VIN Stamping in Trunk – Revised Location

MODEL 1996 MY-ON
Sedan Range
VIN
764048-ON

ILLUSTRATION 1

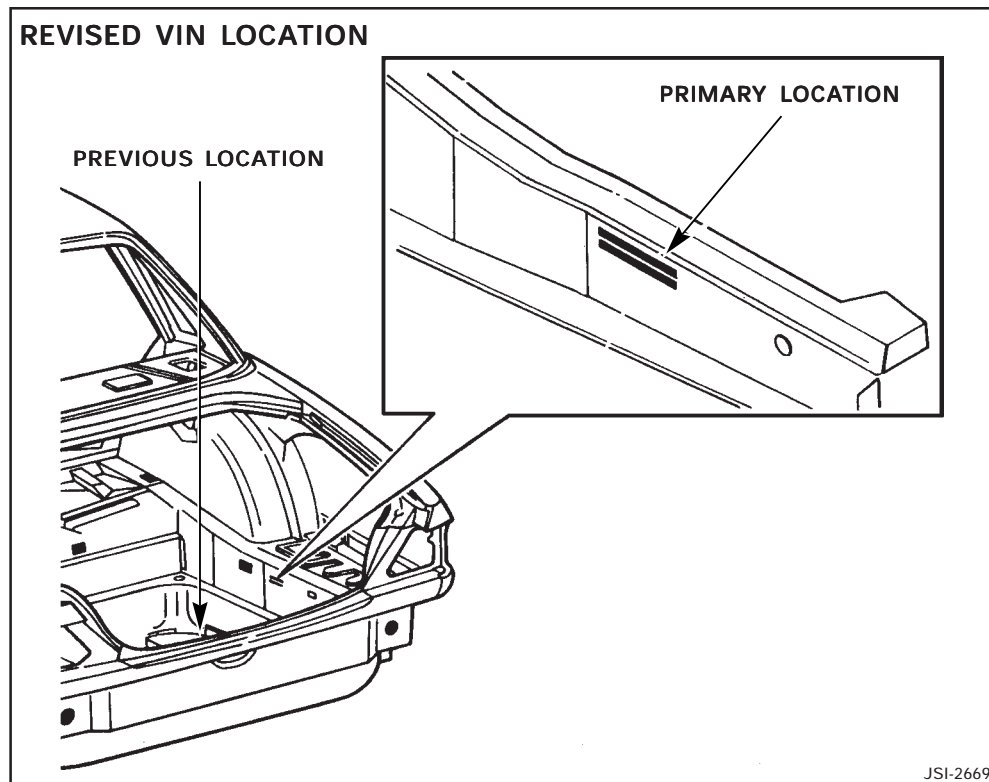
The location of the VIN stamping in the trunk was changed starting with VIN 764048.

The number was previously stamped on the area of the floor between the battery and the spare tire. The revised location is on the vertical face, adjacent to the battery.

The primary location for the VIN is shown in Illustration 1. A secondary location is available in the event the primary stamping needs to be obliterated during vehicle production.
